Structural Compliance Certificate (Construction)

Description of Inspection: Steel Frame, Steel Trusses and Structural Steel Inspection for Proposed Building 3

Our Reference: Your Reference:	BR200435-SC-Building3-rev02				Level 7 22 Cordelia S South Brisbar	
19/09/2023					T 07 3844 590	00
					www.acor.cor	n.au
Richard Crooke Level 3, 4 Broa	s Construction P/L				ENGINEERS	
Artarmon, NSW					MANAGERS	
,					INFRASTRUC PLANNERS	CTURE
Attention: Ms Ar	ngela Wang				DEVELOPME CONSULTAN	
Dear Angela,						
STRUCTURA	ctural Certification – Build	uilig 3				
Site Details:						
Project Name.	Kingscliff Public School					
Street no. / Stree	•					
Suburb:	Kingscliff	State:	NSW	Postcod	e: 2487	
Description of	Work:		New double st	orey classroo	ms (Building 3)	
Consent:						
SSD No. SSD-8378620-MOD-1		Consent auth	nority:	N/A		
			Dated:		15 June 2023

SITE INSPECTION REPORT

Drawing Title
STRUCTURAL
BUILDING 3 - GROUND FLOOR PLAN

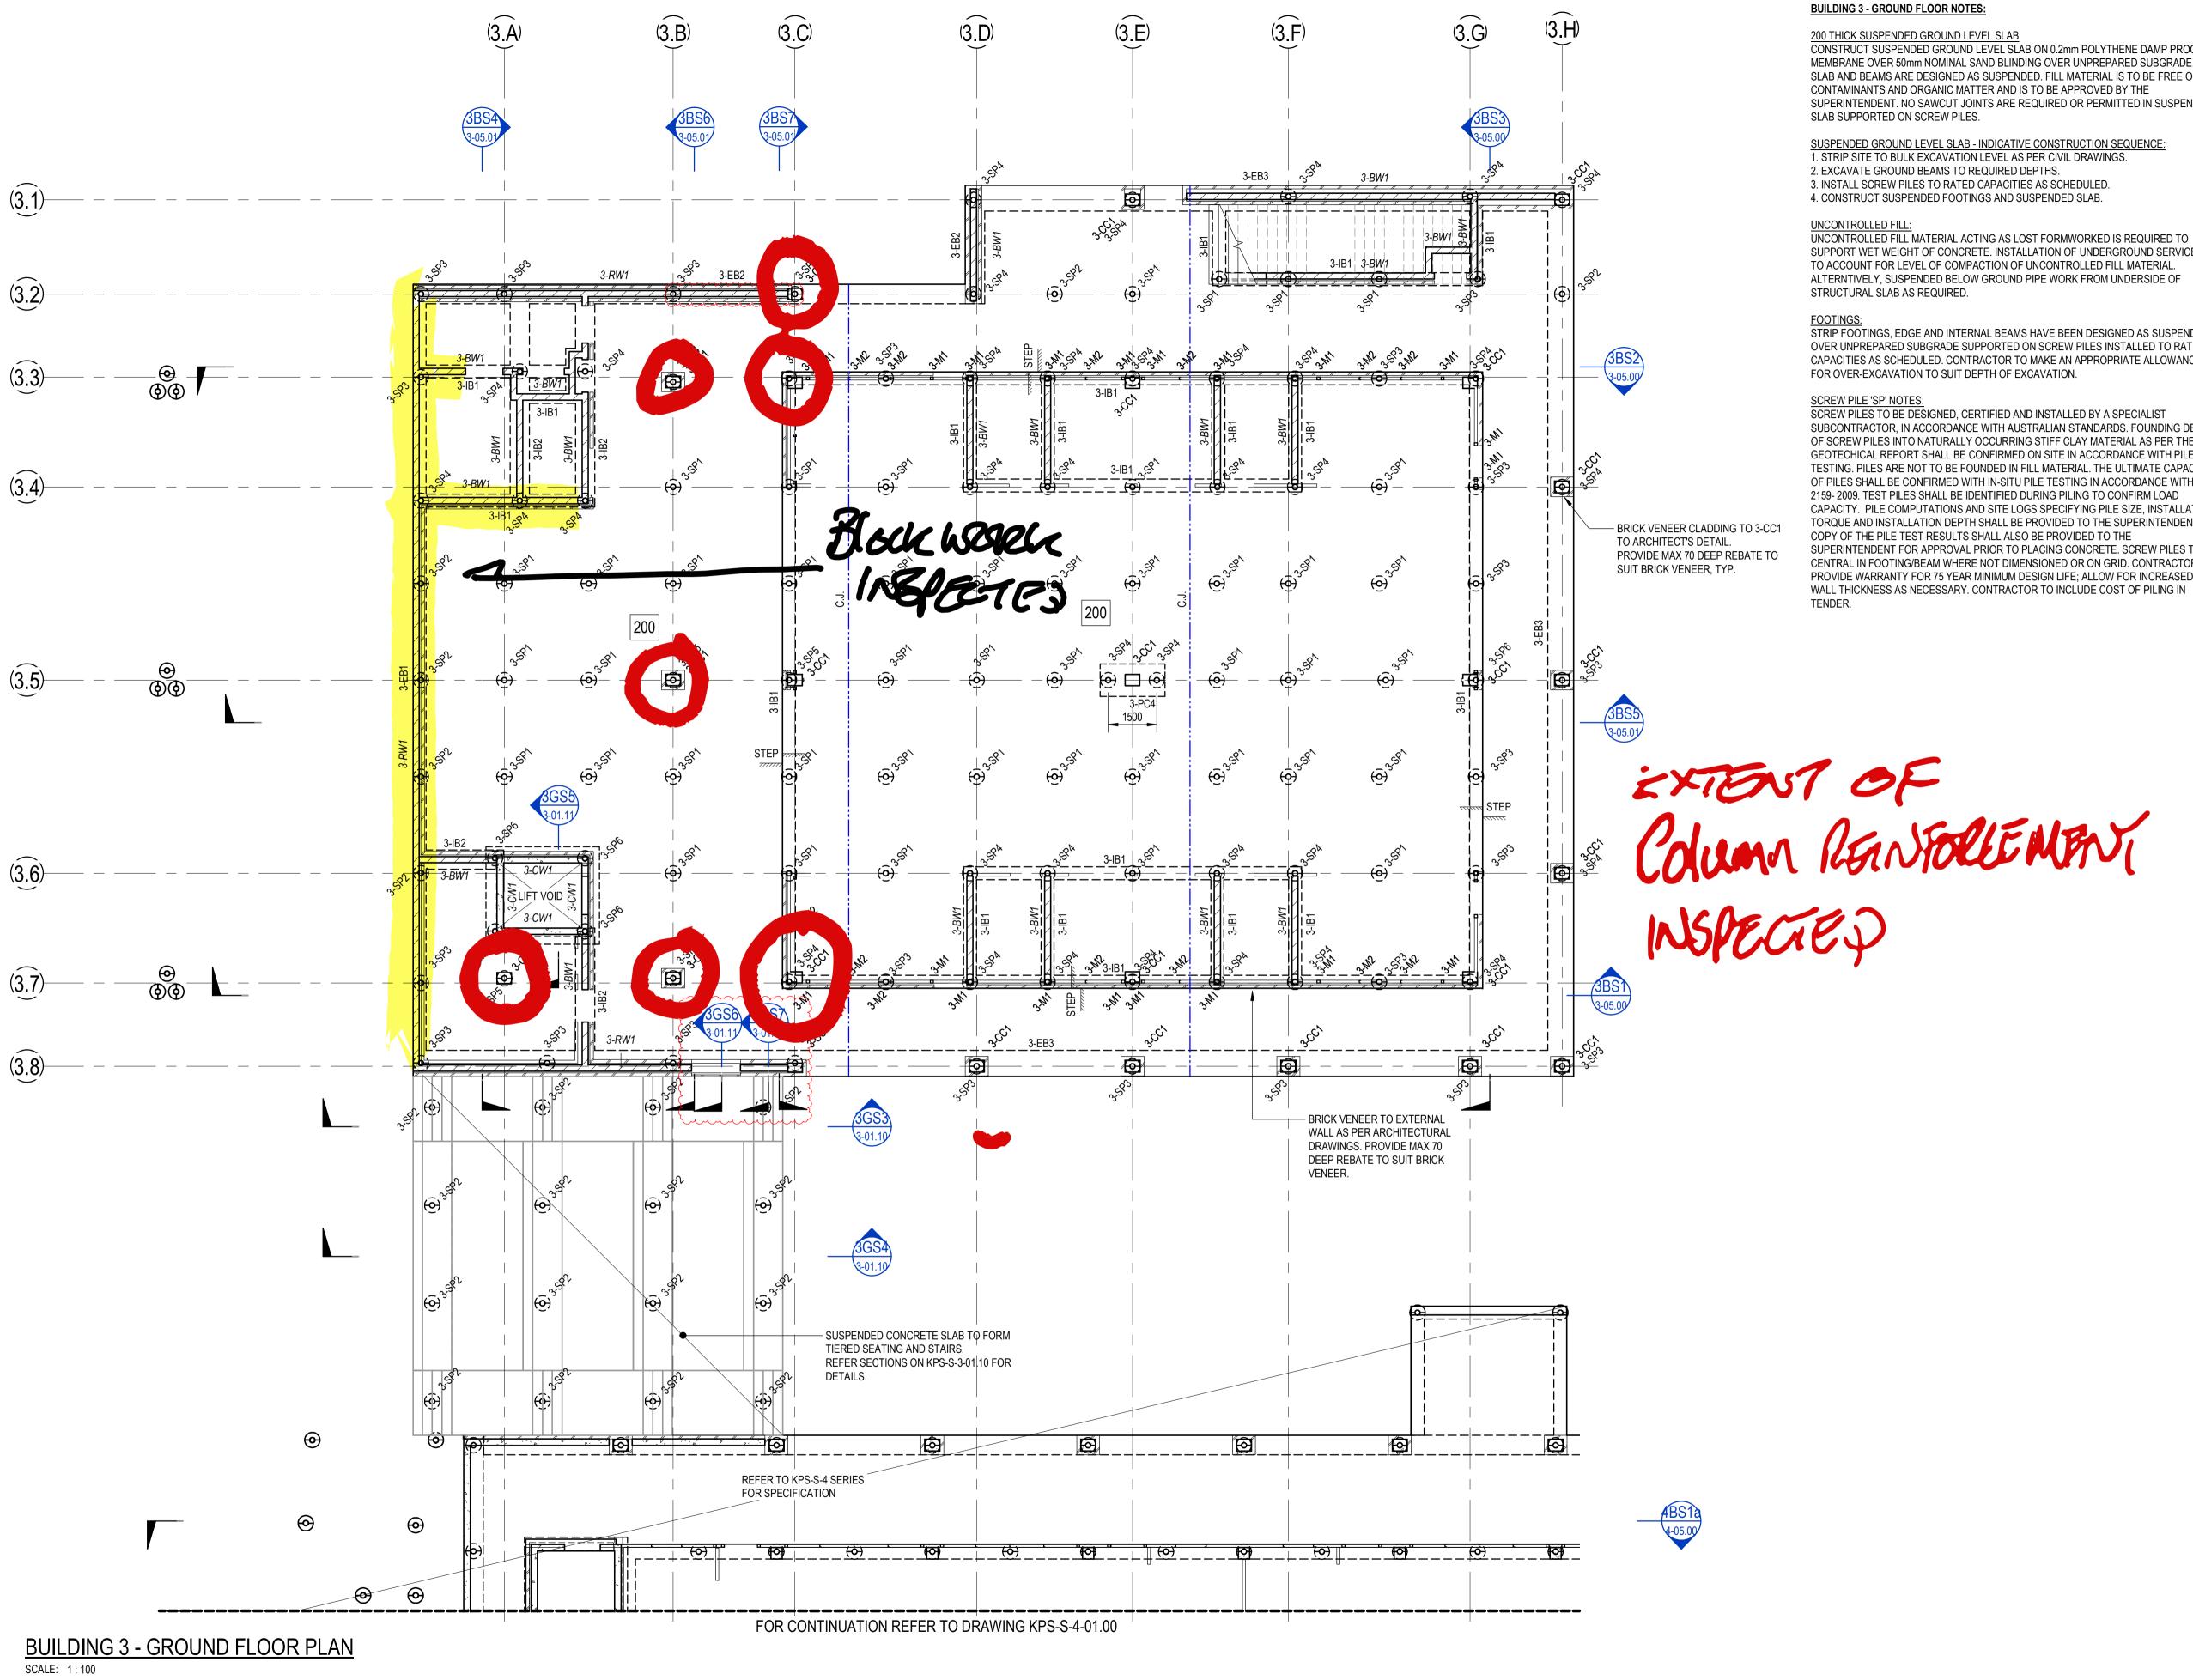
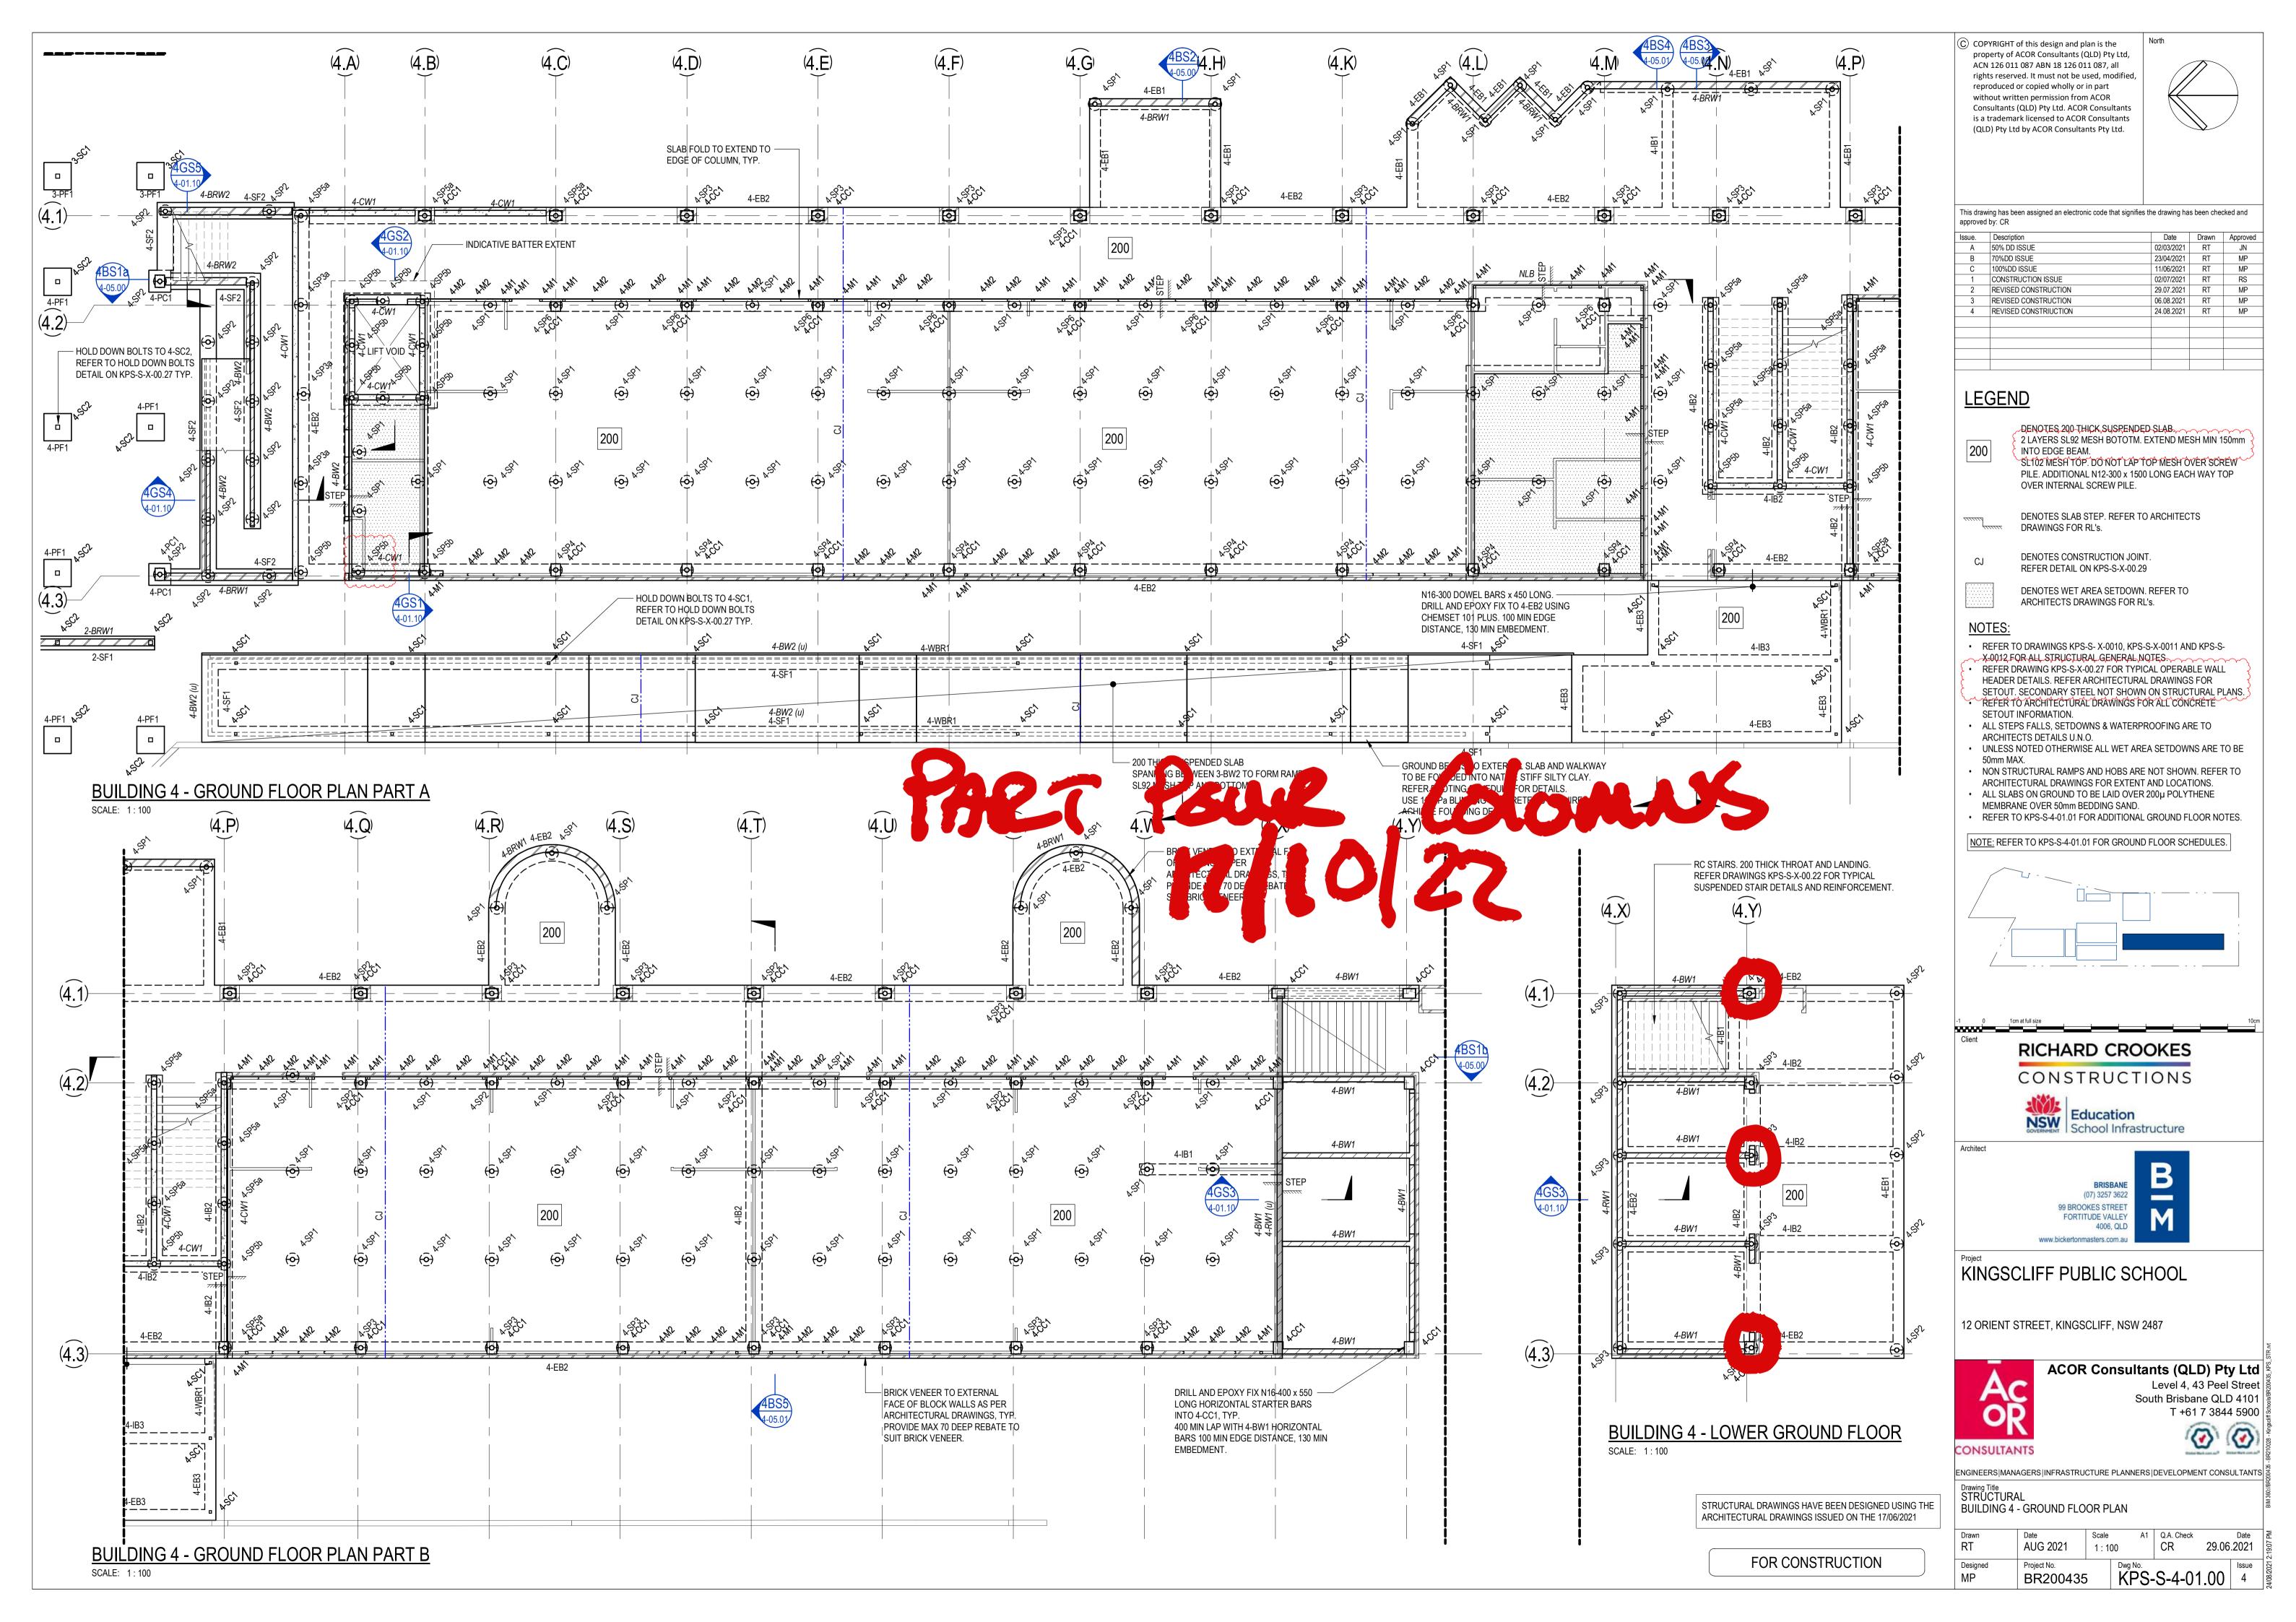
1. TIE OFF REMAINSING CENTRAL FITMENTS 2. PLACE CORRECT L' BARS TO
2. PIACE COLLECT L' BALLS TO
3. INTERSECTING BLOCK WHILS. 4 EXTENT PREFER MARK UP.
4 EXTENT DEFER MARK UP.
5.
6.
7. WHEN ABOVE COMPLETE - OR TO POUR.
8.
9.
10.
11.

TYPICAL DOOR OPENING REINFORCEMENT SCALE 1:20

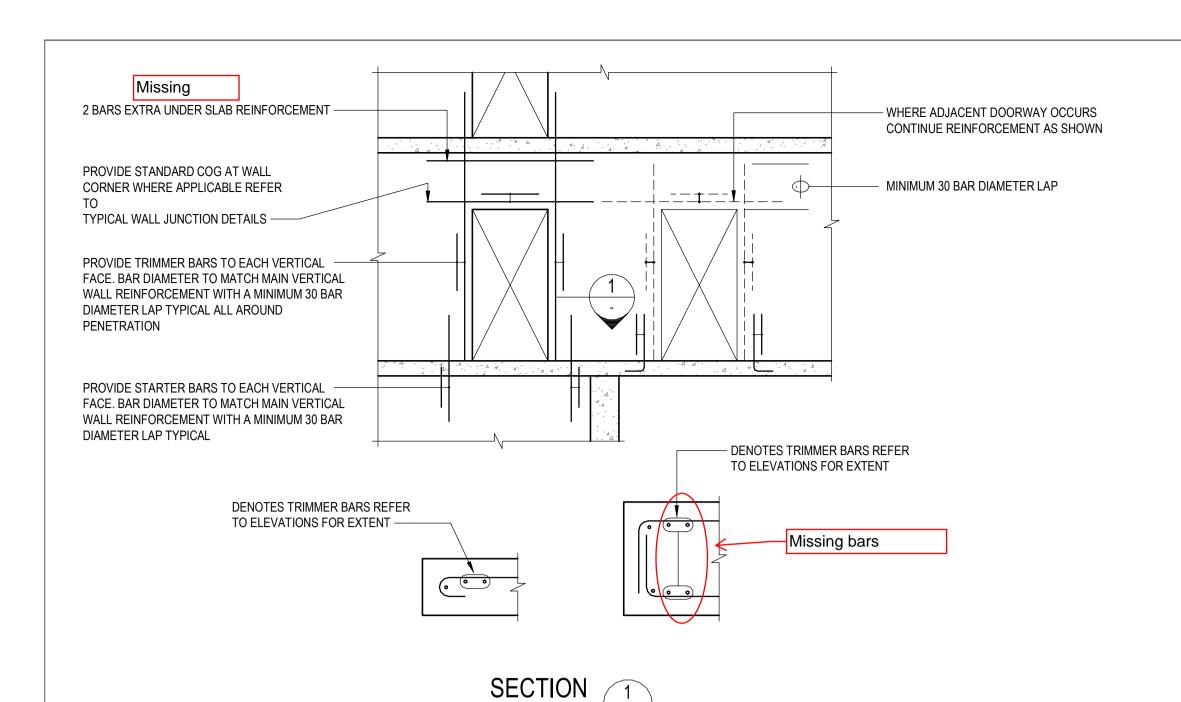
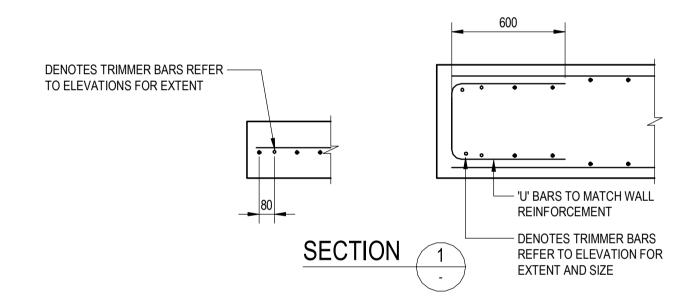
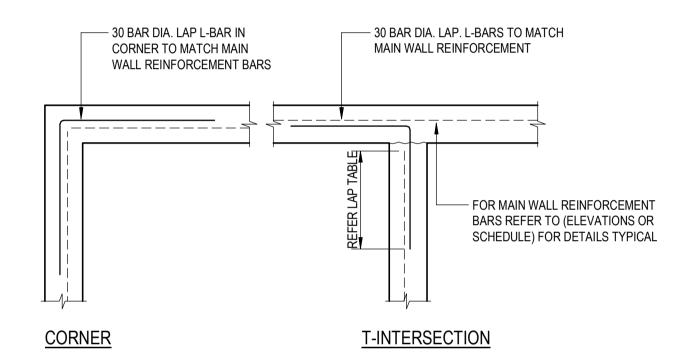
A
1. ADD VERTICAL TRIMMER BARS -S 2. AT DOOR OPENSING AS PER 3. DRAWING -SEE ATTACHED.
2. AT DOOR OPENING AS PER
3 DEAWING -SEG ATTACHED.
4.
5. PLACE WALL CORNER BAILS COPETUJ 6. FOR DEVELOPMENT REFER ATTACHES
6. FOR DEVICES PMENT REFER ATTACHET
7
8. PROUDE 2 EXTRA BAR SUNDER 9. SLAB ABOUT DOOK - REPER 10. ATTACKED.
9 SLAB ABOUT DOOK - KERTER
10. ATTACKED.
11.
ENSULE COLLET CONFIR

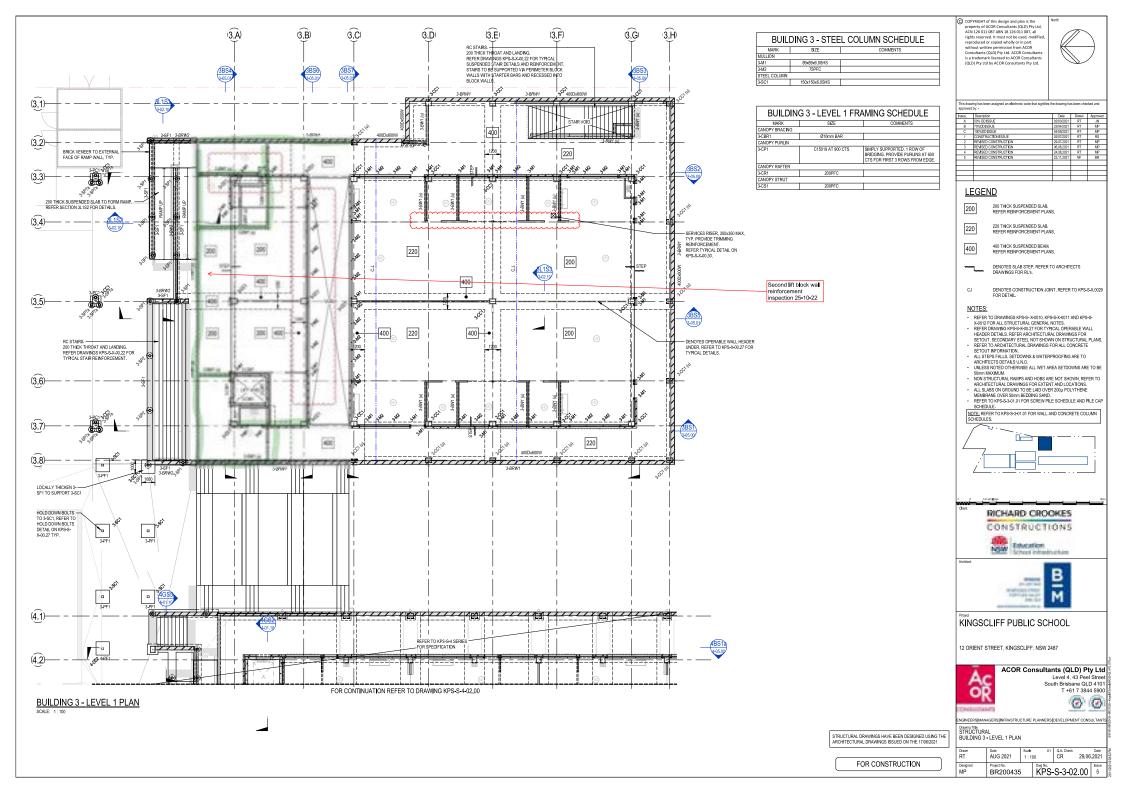
1.	1						
1.	HOO	D RE	Mina	cg UE	TULU	to R	Als
2.		-		1			
3.			(
4.	OK	tes	Four	2			
5.							
6.							
7.							
8.							
9.							
10.							
11.
